APPLICATION NO.	FILING DATE	FIRST NAMED INVENTOR	ATTORNEY DOCKET NO.	CONFIRMATION NO.
10/810,142	03/26/2004	Ephraim Jeff Gutmark	139141	8853

Office Action Summary	Application No.		Applicant(s)	
	10/810,142		GUTMARK ET AL.	
	Examiner		Art Unit	
	Ted Kim		3746

METHODS AND APPARATUS FOR OPERATING GAS TURBINE ENGINES
 INVENTOR: EPHRAIM J. GUTMARK, et al.
 DOCKET: 139141
 ATTY: ROBERT B. REESER, III; PHONE: (314) 621-5070
 REPLACEMENT SHEET

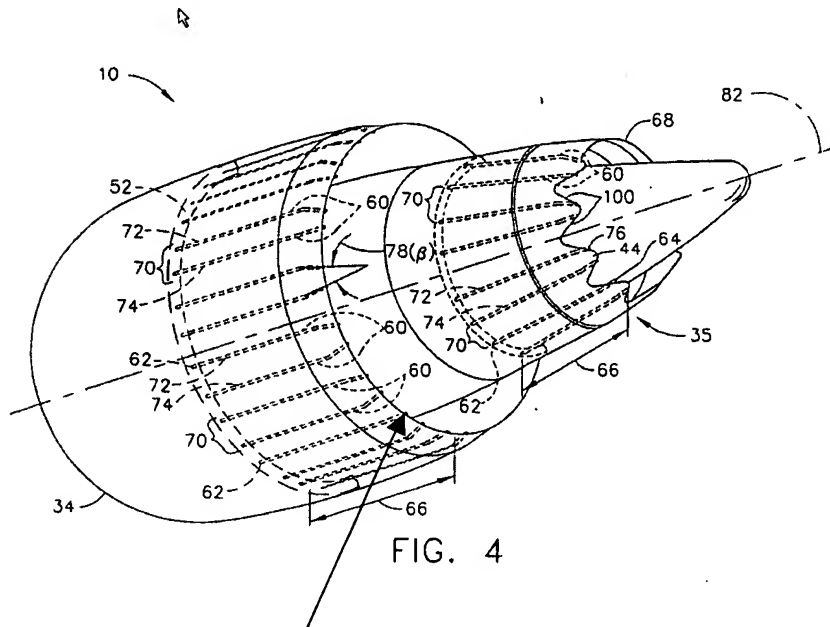
For Figures 4, 6, the tubes 70 are not shown with **triangular chevrons** on the fan exhaust nozzle 30. The following paragraphs make it clear that the tubes are to be used on both sides of the chevrons but this is not properly illustrated for the fan nozzle 30. There are no chevrons illustrated for the fan nozzle 30, only for the core nozzle.

Where are the chevrons for nozzle 30?

FIG. 3

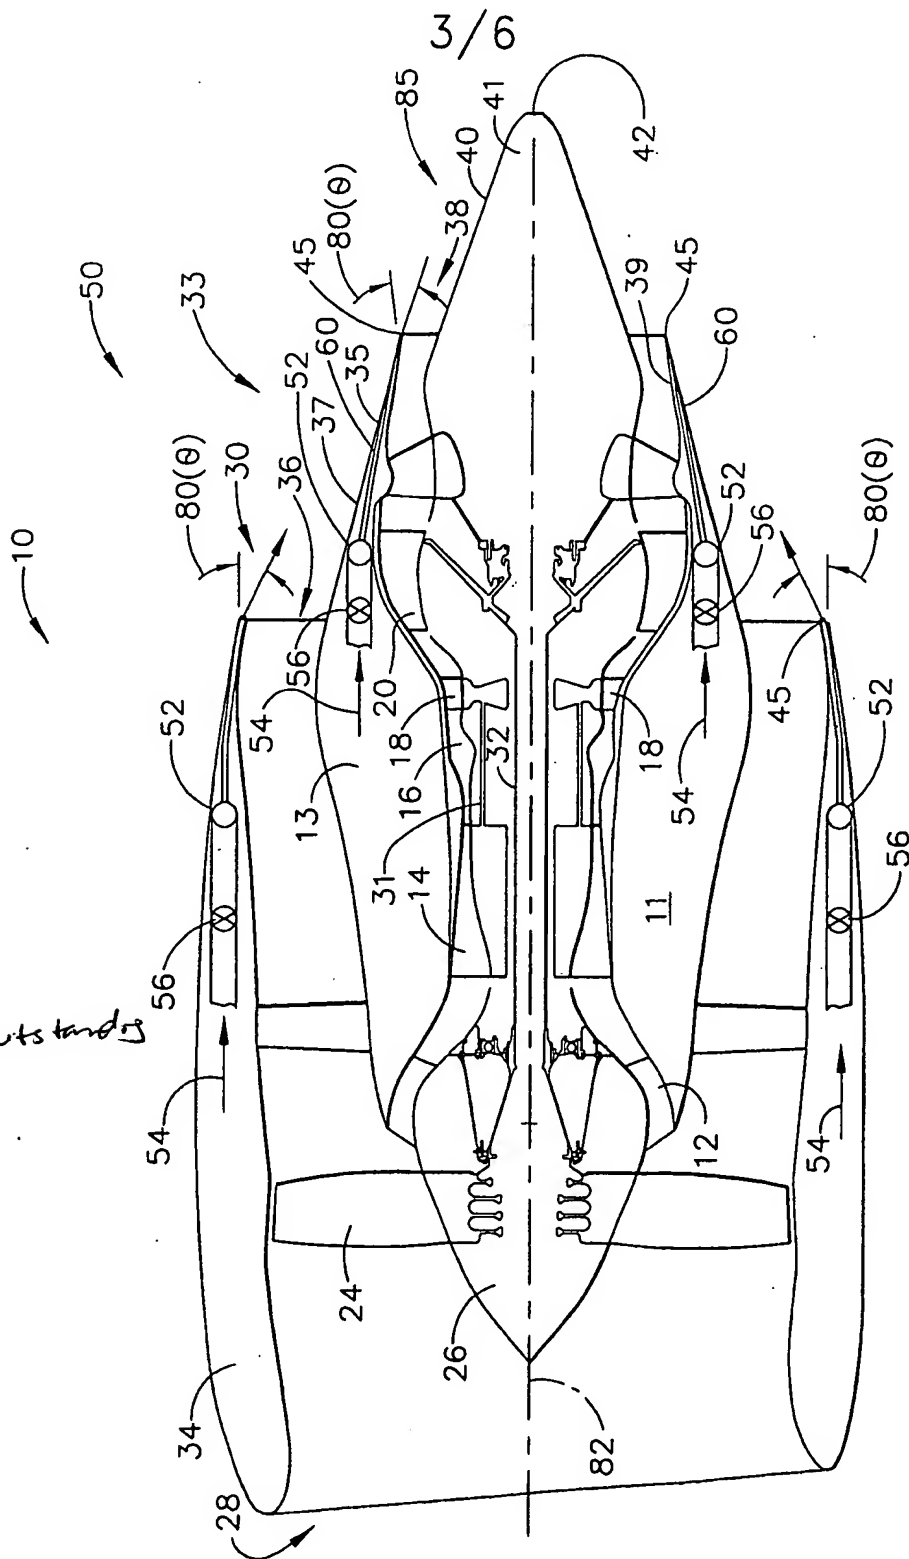
1. The drawings are objected to for failing to correspond with the specification. The following problems have been identified for Figs. 3 and 4:

Entry
 Approved.

Other
 objections
 remain outstanding
